UNITED STATES PATENT AND TRADEMARK OFFICE

APPLICATION NO.	FILING DATE	FIRST NAMED INVENTOR	ATTORNEY DOCKET NO.	CONFIRMATION NO.
10/574,996	04/06/2006	Jean Razafiarivelo	003D.0096.U1(US)	2288
29683 7590 04/25/2007 HARRINGTON & SMITH, PC 4 RESEARCH DRIVE SHELTON, CT 06484-6212			EXAMINER IMAS, VLADIMIR	
			ART UNIT	PAPER NUMBER
			2839	
SHORTENED STATUTORY PERIOD OF RESPONSE		MAIL DATE	DELIVERY MODE	
3 MONTHS		04/25/2007	PAPER

Office Action Summary

DETAILED ACTION

Fig 2

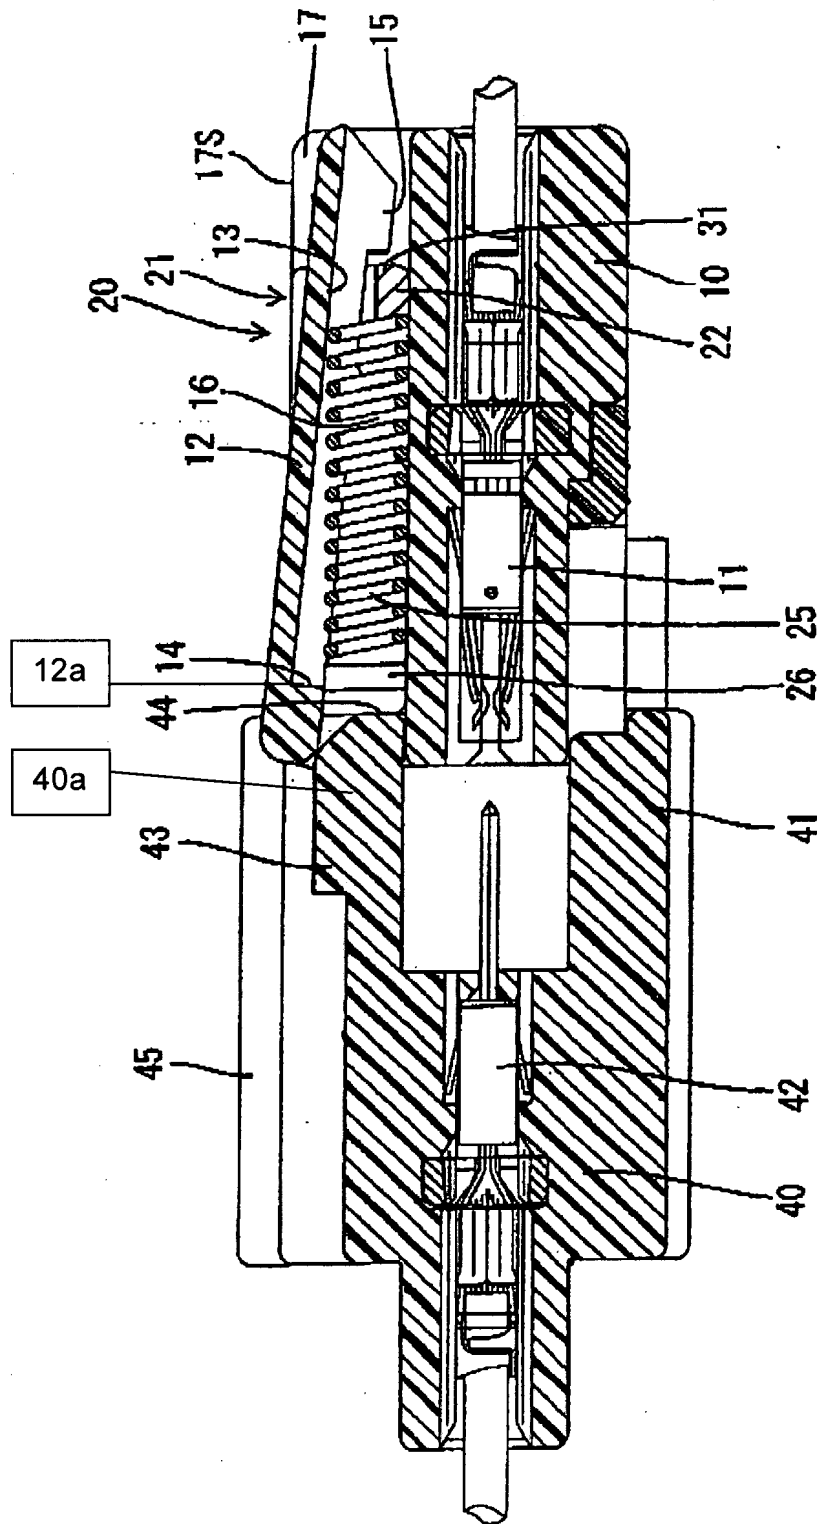
Regarding claim 1, Nakamura, fig. 1-11, discloses an electrical connector

comprising: a cover 40 equipped with at least one first electrical contact 42; a case 10 equipped with at least one second electrical contact 11; and a disconnection device 12 that cooperates with the cover and with the case in order to establish an electrical connection between the first contact and the second contact, which defines a connected state, fig. 1a; and in order to bring about a disconnection between the first and the second contact, which defines a disconnected state, fig. 1c, characterized in that the electrical connector also comprises a first means of locking 40a that makes it possible to maintain the disconnection device in the connected state; a release 14 that acts on the first means of locking in order to permit the movement of the disconnection device from a connected state to a disconnected state of the first and second contact; and an elastic member 25 placed between the case and the cover, the member being capable of being moved between a first deformed position in the connected state and a second relaxed position in the disconnected state, the elastic member bringing about a separation of the case with respect to the cover, while disconnecting the first contacts from the second contacts when the elastic member changes its position from the deformed position toward the relaxed position when the movement of the disconnection device is triggered by the release.

Regarding claim 9, Nakamura discloses that the disconnection device is recessed by a groove 12a comprising a shape that is adapted to the shape of an end 43 of the first means of locking.

Regarding claim 19, Nakamura discloses a process for electrical disconnection of an electrical connector comprising: a cover 40 equipped with at least one first electrical contact 42; a case 20 equipped with at least one second electrical contact 11; and a disconnection device 12 that cooperates with the cover and with the case in order to establish an electrical connection between the first contact and the second contact, which defines a connected state, and in order to bring about a disconnection between the first and the second contact, which defines a disconnected state, characterized in that it includes the following step; a release 14 is moved in order to dislodge from a groove 12a recessed in the disconnection device a first means of locking 40a by at least at height corresponding to the depth of the groove.
